Access Compliance Report Public Rights-of-Way (Curb Ramps)

Main Street: RAINBOW_DR Cross Street: DEAN_ST Location: S

ADA ID: RPRK211014152218 Ramp Type: Type 1 - Perpendicular Diagonal Initial Pass/Fail: Fail Overall Compliance: No Severity Score: 2

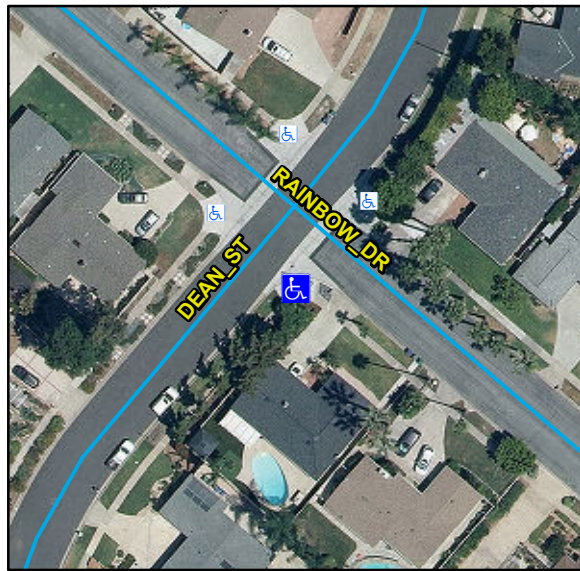
Compliance	Description	Data	Compliance	Description	Data
N/A	Ramp Length (in)	122	N/A	Flare Type LT	
Yes	Ramp Width (in)	48			N/A
Yes	Ramp Run Slope (%)	7.8	N/A	Flare Slope LT (%)	N/A
No	Ramp Cross Slope (%)	3.6	N/A	Flare Traversable LT	N/A
N/A	Landing Present	N/A	N/A	Flare Type RT	
N/A	Landing Length (in)	N/A			N/A
N/A	Landing Width (in)	N/A	N/A	Flare Slope RT (%)	N/A
N/A	Landing Run Slope (%)	N/A	N/A	Flare Traversable RT	N/A
N/A	Landing Cross Slope (%)	N/A	N/A	DWS Provided	N/A
N/A	Landing Movement Obstructed?	N/A	N/A	DWS Contrast	N/A
	Landing Movement Type	N/A	N/A	DWS Length (in)	N/A
N/A	Landing Shared	N/A	N/A	DWS Full Width	N/A
N/A	Clear Space	Yes	N/A	DWS Offset Left (in)	N/A
N/A	Clear Space To Crosswalk (in)	N/A	N/A	DWS Offset Right (in)	N/A
N/A	Marked Crosswalk 1	No	N/A	Marked Crosswalk 2	No
	Crossing 1 Direction	NE		Crossing 2 Direction	NW
	Marked Crosswalk 1 Width (in)	N/A		Marked Crosswalk 2 Width (in)	N/A

Remove & Replace Curb Ramp With Two New Directional Ramps or Equivalent.

R304.5.3, STD 1115
